DOCKET: EPA-HQ-OAR-2019-0534

TECHNICAL SUPPORT DOCUMENT

FOR SECTIONS 194.23, 194.32, 193.33, AND 194.54 REVIEW OF CHANGES TO WIPP PERFORMANCE ASSESSMENT FEATURES, EVENTS, AND PROCESSES IN THE 2019 CRA

April 2022

Figure A-1. Live microbe cell numbers and volume in effluent and mock injection brine (from Lucero et al. 1996, Figure 3).

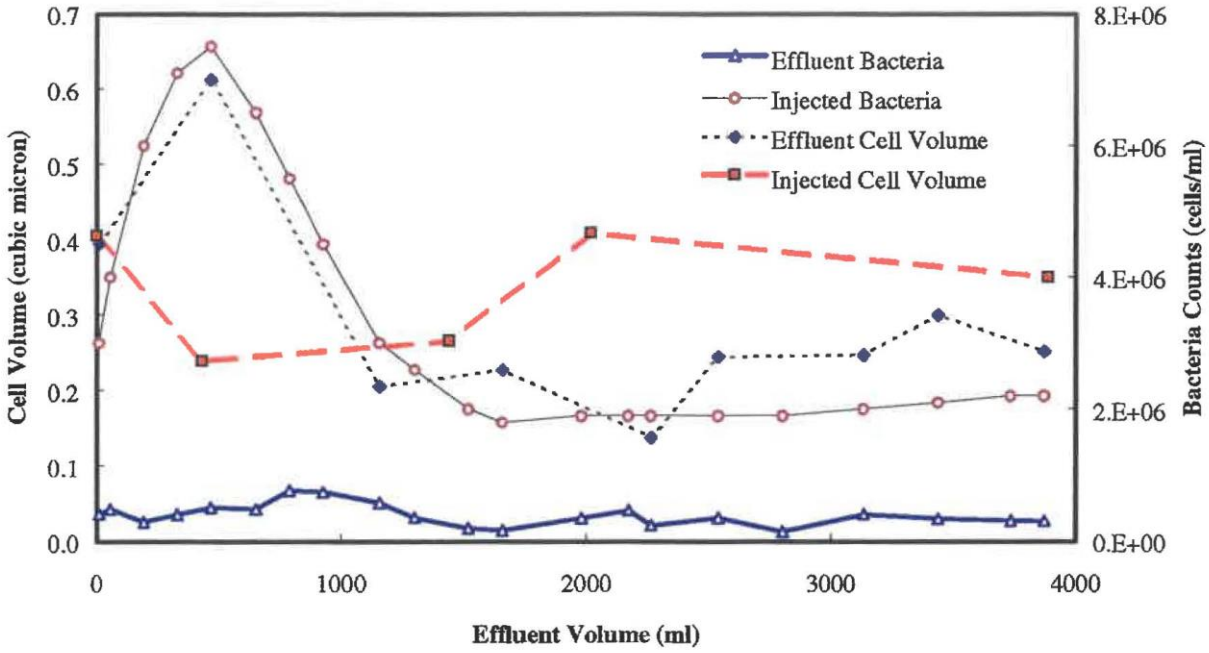
The use of live microbes in the test and the use of a non-sterile core also imposed difficulties in interpreting the results. The results of Lucero et al's column test are reproduced below in Figure A-1. The immediate presence of microbes in the effluent fluid at test startup suggests that either the microbes in the inoculant moved very quickly through the core or that the observed microbes were already in the core and were being flushed out by the injected brine. It was apparently difficult for the researchers to distinguish the inoculated microbes from native microbes.

EPA concludes that, although some microbes are likely filtered out during transport in the Culebra, the continued, persistent presence of a fraction of the injected microbes in the effluent brine of Lucero et al's (1996) test does not support the DOE's conclusion that all microbes are rapidly filtered out in the Culebra. This lack of support, coupled with the lack of documentation regarding the representativeness of the core sample used in the test and the inability of tests on crushed Culebra dolomite to adequately simulate flow through fractures, renders the DOE's conclusion of rapid microbe filtration to be inadequately supported. EPA's comments on FEP W23 Subsidence are also relevant to this FEP because vertical and horizontal strains associated with subsidence due to repository excavations as well as potential subsidence due to mining are expected to open existing fractures, increase Culebra transmissivity, and may decrease filtration. Please see Comment CC3-SCR-3 in this appendix. EPA expects DOE to review the screening argument for this FEP for the CRA-2024 and either screen it in into WIPP PA or provide an adequate justification for continuing to screen it out.
